Office Action Summary	Application No. 10/708,035	Applicant(s) ECONOMIKOS ET AL.	
	Examiner DAVID VU	Art Unit 2818

DETAILED ACTION

2. Claims 19-24, 27-29 and 30 are rejected under 35 U.S.C. 103 (a) as being unpatentable over Karlsson et al. (US Pat. 6,124,183, hereinafter Karlsson) in view of Kim et al. (US Pat. 7,078,314; hereinafter Kim)

Figure 2G

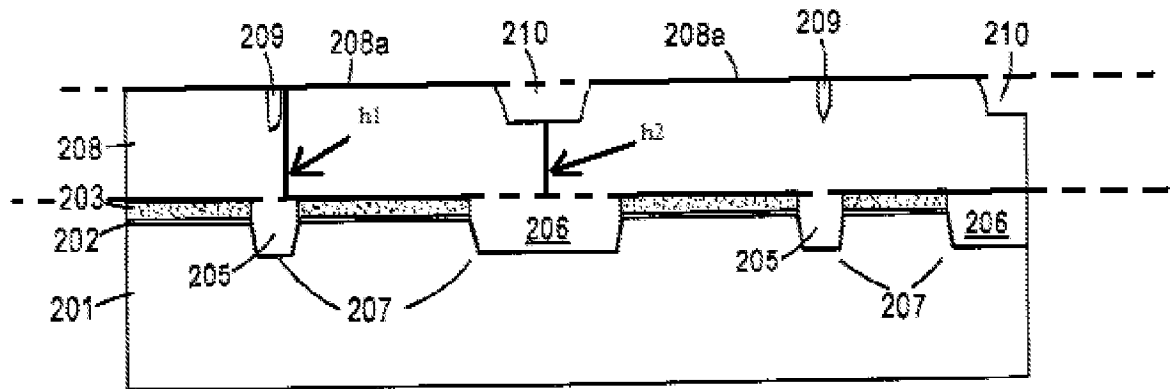
***Regarding step (d) (iii), as shown in fig. 2G of Karlsson, before the mask/removing step, (same step (i) and (iii)) of the present application), the fill material 208 is thicker over the planarization stop layer 203 than over the trench 205/206 (due to the gaps 209/210 are formed on each trench). Since the first set of trench (trench 205) area is exposed under the same etching condition, the amount of the fill material 208 being etched over the planarization stop layer 203 and over the trench 205 is the same. As a result, at some point during the removing process, before the gap 209 is planarized or before the layer 208 having a substantially planar upper surface, the remaining layer of fill material 203 must be thicker over planarization stop layer 203 between adjacent trenches of first set of trenches 205 than over each trench of first set of trenches 205. Moreover, it would have been an obvious matter of design choice bounded by well known manufacturing constraints and ascertainable by routine experimentation and optimization to choose these particular dimensions because applicant has not disclosed that “a remaining layer of said fill material thicker over said planarization stop layer between adjacent trenches of said first set of trenches than over each trench of said first set of trenches” are for a particular unobvious purpose, produce an unexpected result, or are otherwise critical,

Figure 2I

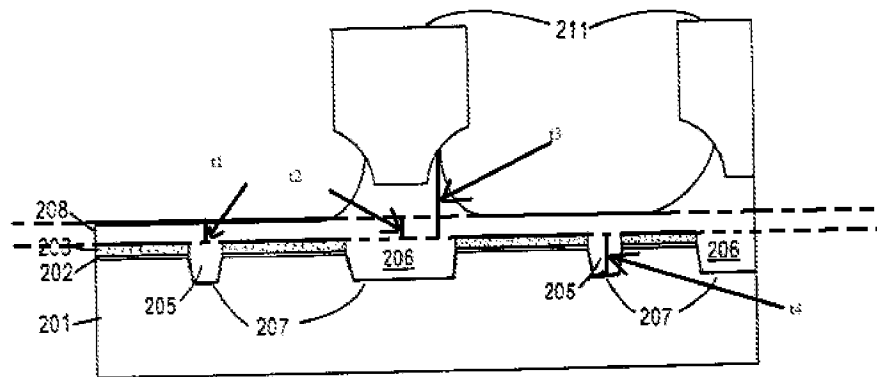
(iii) removing a layer of fill material 208 exposed in opening, fill material 208 still completely filling each trench of first set of trenches, after removing a layer of fill material 208, fill layer of material 208 thicker over planarization stop layer 203 (t3) between adjacent trenches of first set of trenches 205 than over fill material contained within each trench of said first set of trenches (208 material inside trench 205; t4) (col. 5, line 54-60 and fig. 2I); and

Regarding claim 19, at some point during the removing process, t1 = t2 (when the layer 208 having a substantially planar upper surface).
